**CITY OF MENASHA
PLAN COMMISSION
Council Chambers
140 Main Street, Menasha**

**September 21, 2010
3:30 PM**

CITY OF MENASHA
Plan Commission
Council Chambers, City Hall – 140 Main Street
September 14, 2010
DRAFT MINUTES

1 NORTH EXTERIOR ELEVATION
A-4.1 1/8" = 1'-0"

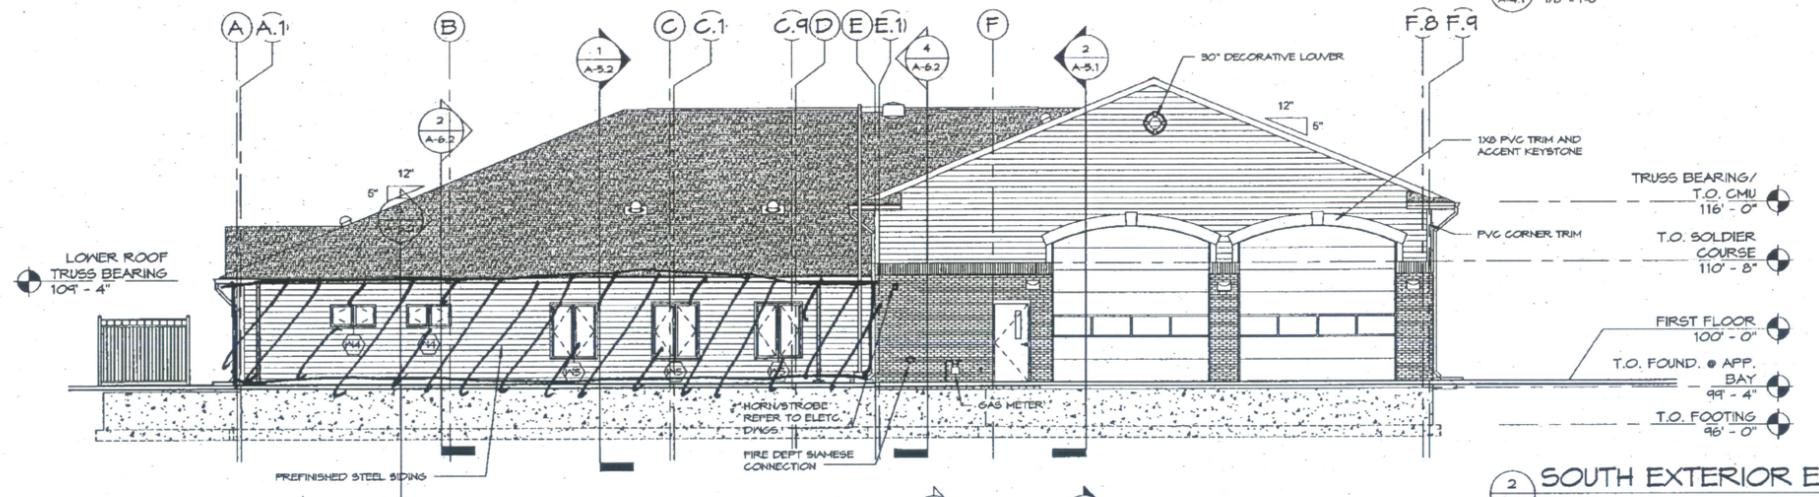
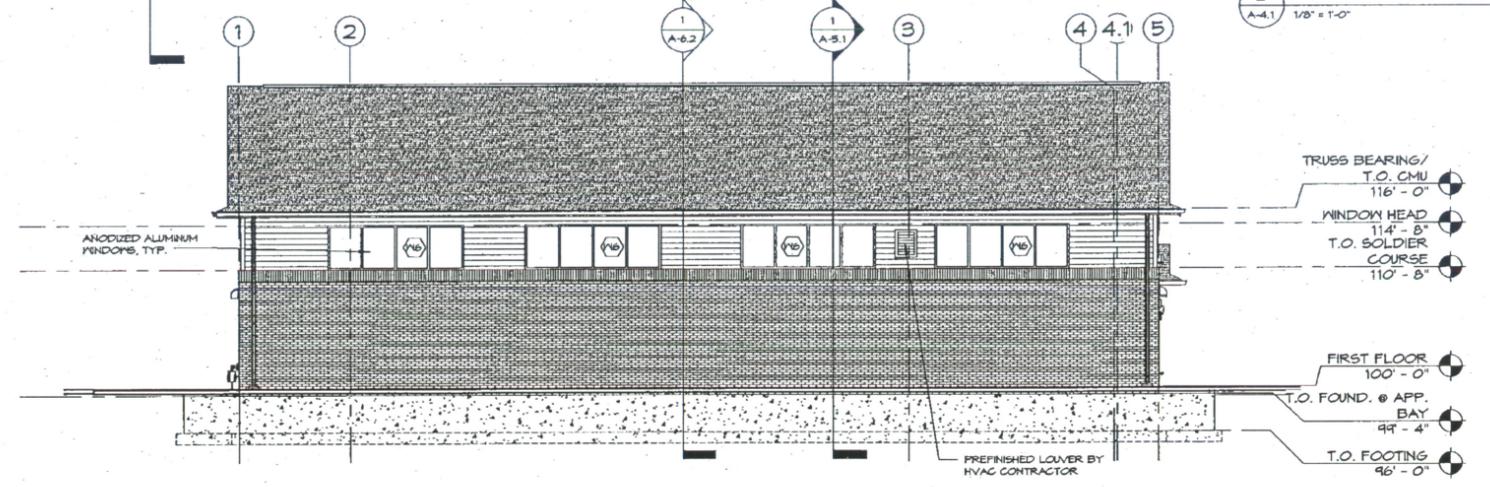
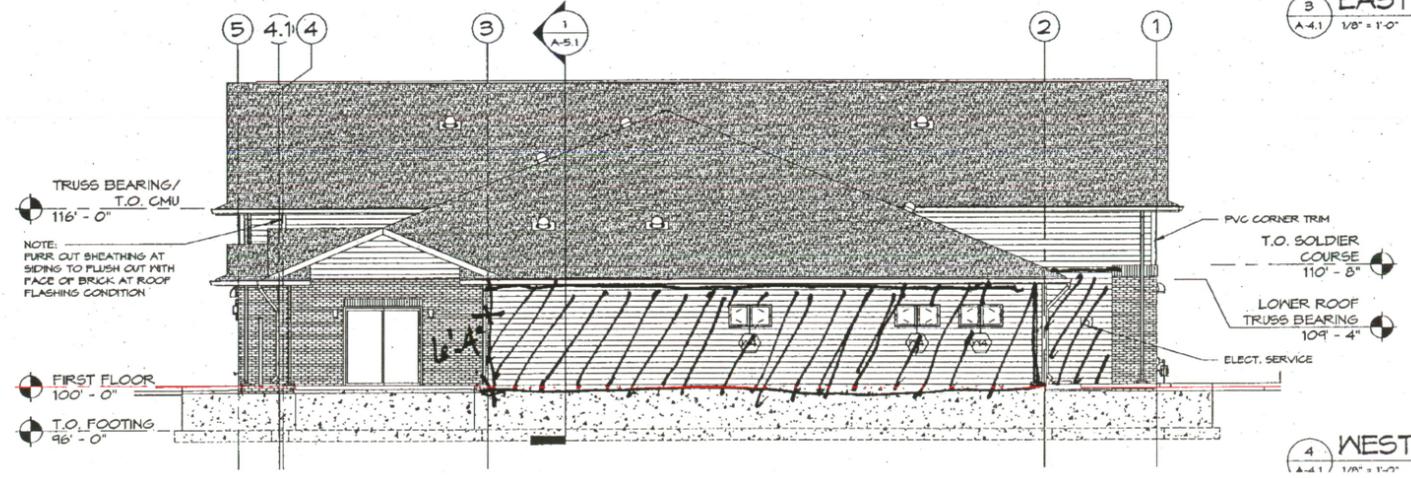
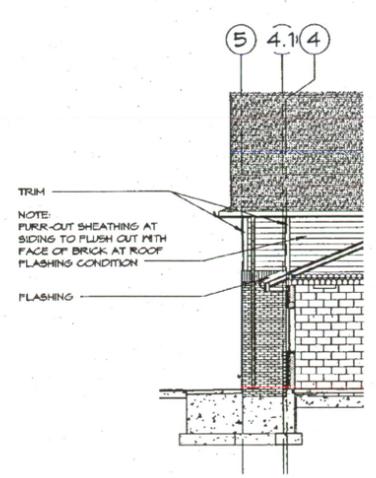
PP Kester reviewed the proposed site plan and noted that landscaping plan was lacking certain details and that additional landscaping was needed in the front yard setbacks, the parking lot on Manitowoc Road needs to meet landscape screening requirements, the proposed building materials do not meet the 75% requirement for brick or natural stone, and that additional detail is needed on the lighting fixtures. She also stated that the storm water management plan needs to be reviewed by an independent engineering firm and approved by the Public Works Department.

- The building materials as proposed and the status of the 2005 conditional approval of the site plan
- Cost implications of alternate building materials
- The zoning of neighboring properties
- The implications of rezoning the parcel to GU government use
- Timing issues associated with plan approvals and building construction

The consensus was that staff should review the approval status of the 2005 site plan with the City Attorney and that this item should return on the next Plan Commission Agenda.
